From: Scott Pacheco, AICP
Hamburg Township
Planning

Date: November 16, 2022

Agenda Item: 7b

Project address and Description: **Final Site Plan (SPA 22-003):** Public Meeting to consider the change in use from a residential use to a commercial use at 7878 M-36. This change will also include the conversion of the existing residential home on the site into a commercial facility with a 1,391 square foot showroom and 961 square foot of office space. The project also will include the addition of a new 5,000 square foot pole barn to the rear of the existing structure for storage of products sold from the site.

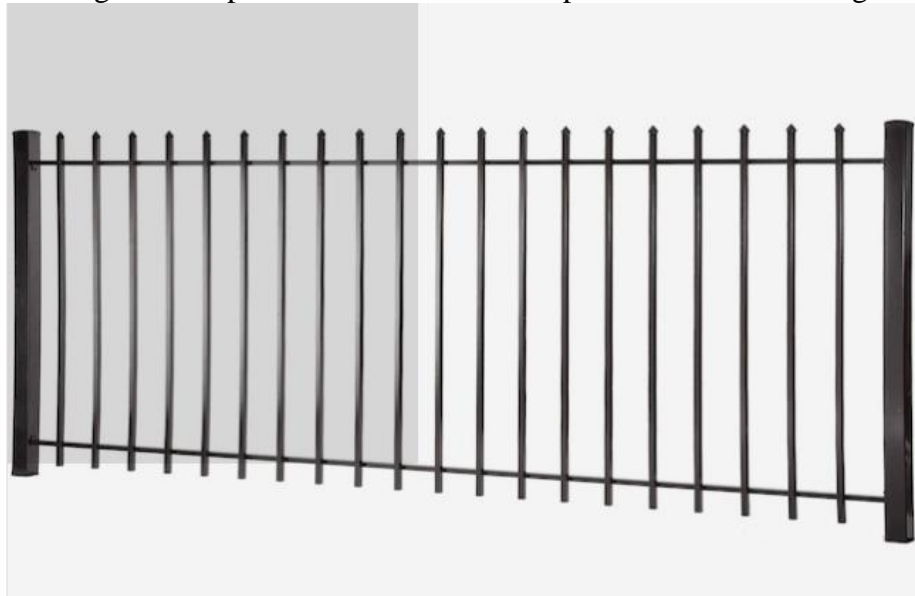
The proposed development will convert an existing single-family home into a commercial use. The existing home is set back over 80 feet from M-36. The proposed project will include landscaping to better screening the property from M-36, an 8-foot-wide multi-use trail that will tie into the existing 8-foot-wide multi use trail on the property to the east and will eventually tie into trails to the west, and proposes paving the existing gravel drive and a new small parking area at the front of the site. The existing garage door facing m-36 will be removed and a glass store front for the carpet store use will be created in this location.

The proposed use will utilize the existing structure on the site. The only changes proposed to the existing structure are as follows: The existing garage door will be removed and a glass storefront area will be built in this location for the proposed carpet store showroom, a handicap ramp will also be installed between the proposed parking area and the entrance to the office use, and two new wall signs are proposed on the front façade of the building for the two proposed uses.
